GSI-191 ACRS Slide Presentation – November 18, 2010 (Non-Proprietary)

# Presentation to ACRS Sub Committee

## **AP1000™ Long-Term Cooling Debris Issue Resolution**

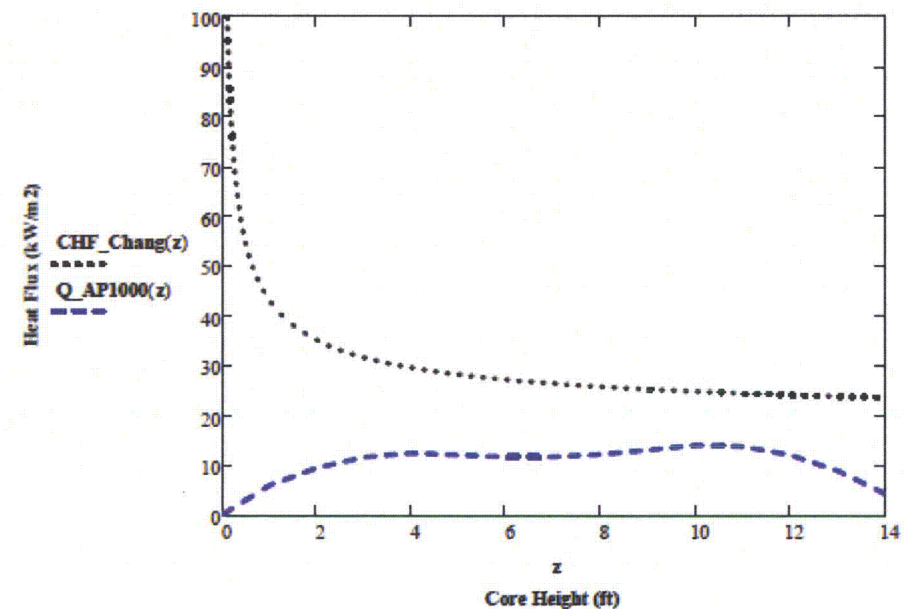
1. What is the margin between the worst-case COBRA/TRAC calculations presented and the flow that would lead to dry-out? In other words, how much would the debris bed loss factor have to be increased in order to lead to dry-out?
2. At what quality would dry-out be expected at the decay heat levels used to generate the table of COBRA/TRAC results presented by the staff?
3. What is the low-pressure, low-flow CHF correlation used in COBRA/TRAC?

- CHF Correlations in WCOBRA/TRAC
  - Lower mass flux ( $< 30 \text{ g/cm}^2\text{-s}$ )
    - Modified Zuber correlation as recommended by Bjornard and Griffith
  - Higher mass flux ( $> 30 \text{ g/cm}^2\text{-s}$ )
    - Biasi correlations for low quality CHF, high quality CHF
- Additional assessment of CHF during LTC against Chang (1991) correlation
  - Correlation developed for low flow, low pressure conditions
  - Consider Case 10 power, flow conditions (8.6 hr after break, 65 lbm/s)
  - Similar to assessment of conditions during accumulator injection period of a SBLOCA

- Minimum inlet flow
  - 65 lbm/s core flow
  - No credit for cross flow/chimney effects
- Hot assembly power
  - $FdH=1.75$
- 20°F inlet subcooling

CHF limit is not exceeded

## Core Collapsed Liquid Level: Nodalization Sensitivity Case Similar to DCD Case

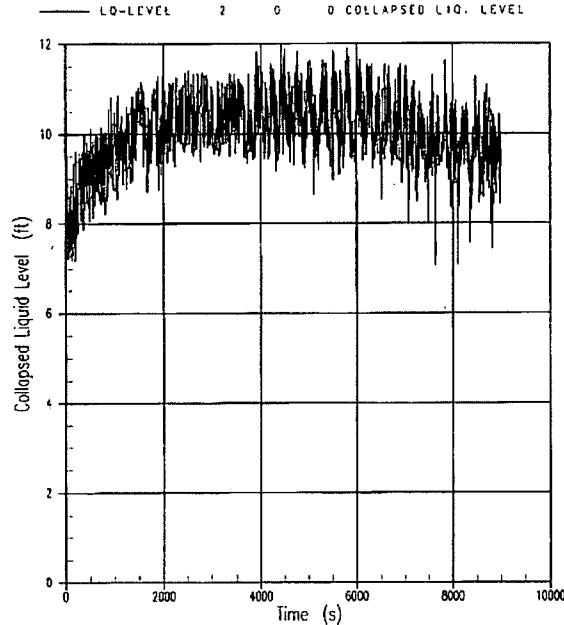
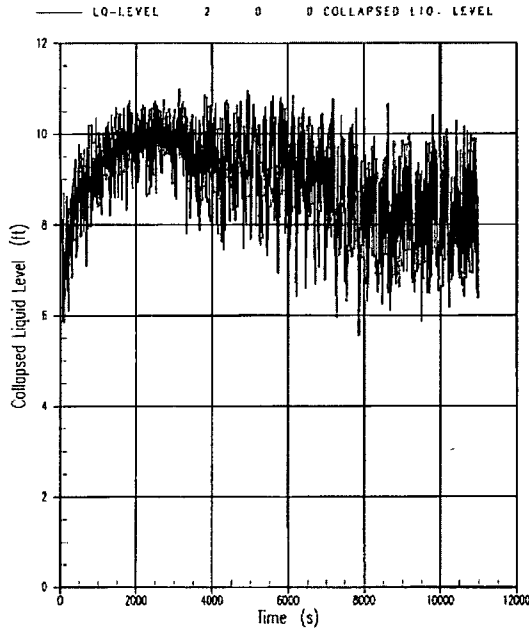
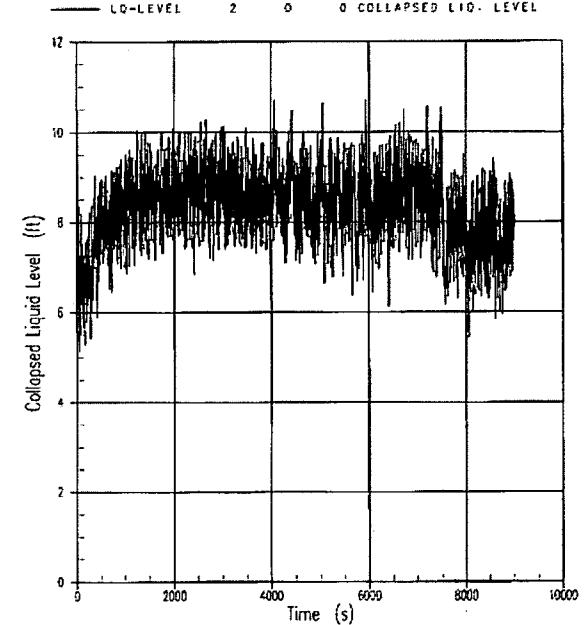
2. How do numerical (nodalization and time-step) convergence tests affect the oscillations seen in the COBRA/TRAC calculations?
3. Do DEDVIGB breaks lead to the lowest driving head conditions? Are there other accident scenarios (e.g., some cold leg breaks) that lead to lower driving heads due to incomplete filling of the downcomer?

### 2. Oscillations in WC/T, nodalization sensitivity

- Previous core nodalization sensitivity studies similar to DCD case examined effect of 7, 10, 14 nodes in core
- Core collapsed liquid level was sensitive to the nodalization
- WC/T LTC model for debris sensitivity cases uses detailed nodalization (17 nodes in core)
  - 17 nodes based on AP1000 fuel design (grid location, etc)
  - Modeling consistent with validation against G1 and G2 boiloff tests

### 4. & 5. WC/T modeling of DP based on flow<sup>2</sup> vs. test results

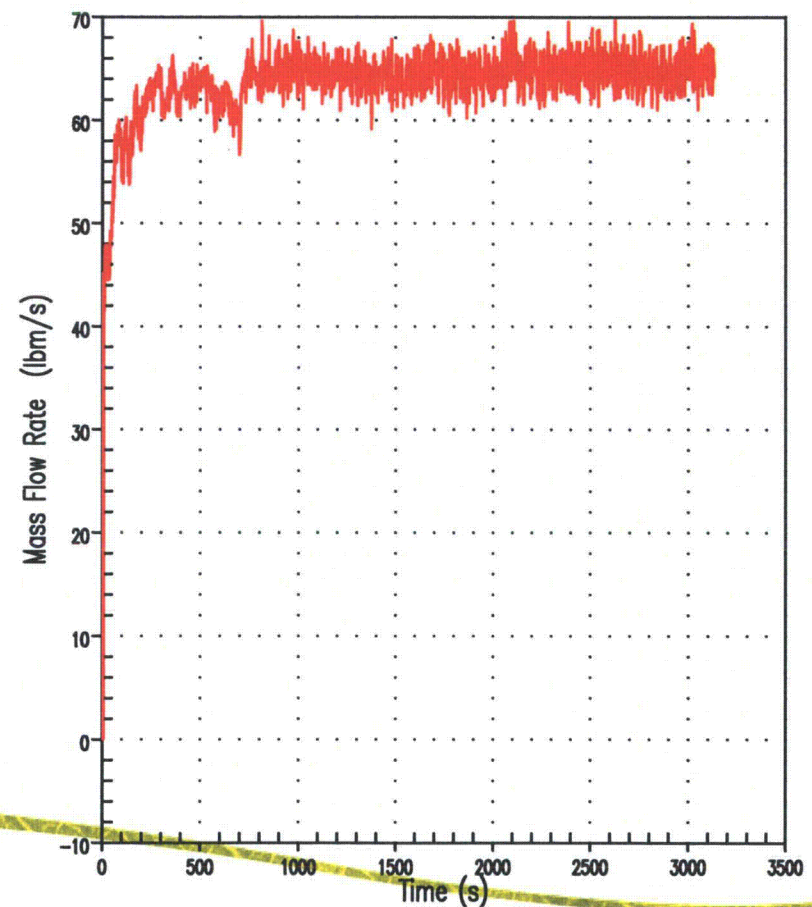
4. If the bed resistance is made a function of velocity as seen in the experiments, how are the oscillations and the average flows and pressure losses affected?

5. If the bed resistance is made a function of flow rate through the debris beds formed, then do these effects change the worst-case scenarios? Does such a flow-dependent bed resistance parameterization lead to lower flows than would be calculated with a constant bed resistance for the worst-case scenarios?

- Flow rate into core in WC/T Sensitivity Case 10 does not vary significantly
- DVI line flows vary more
  - Oscillations in downcomer level accommodate these variations

AP1000 DEDVI in Loop Compartment: Core Entrance K = 4.6E6 K/A<sup>2</sup>=762  
Core Inlet
